P02	19/05/23	Response to RFI	
P01	29/04/22	Issued For Planning	
Revision Number	Date	Drawn	Details of Issue / Revision
Issues & Revisions

Project Details:
 Dalguise
 Monkstown

Drawing Title:
 Proposed Elevations and Sections - Block F + G

MKS-RAU-FG-ZZ-DR-AR-200

BLOCK F + G

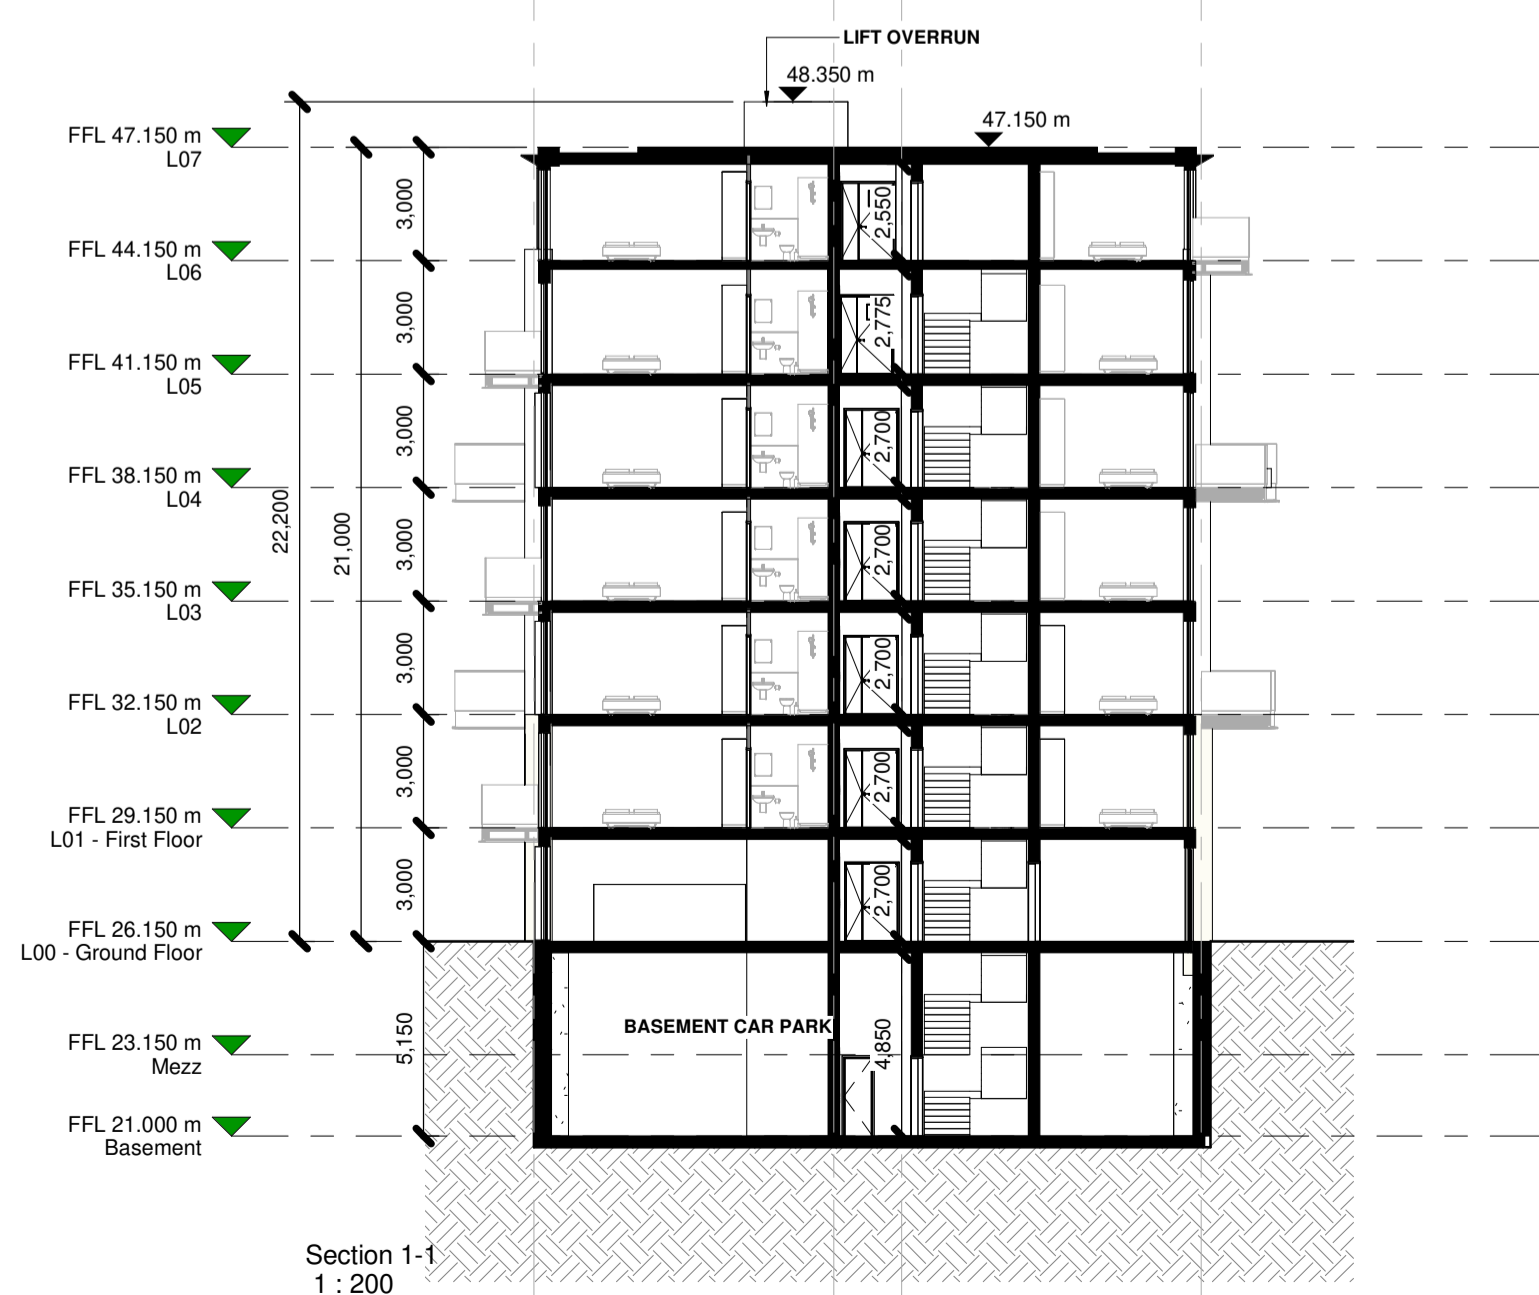
F/G1. Stone added to North East Corner of Building.

F/G 2 Stone Base added to Building - Ground to First floor forming a base plinth.

F/G 3. Tone of metal set back floor amended.
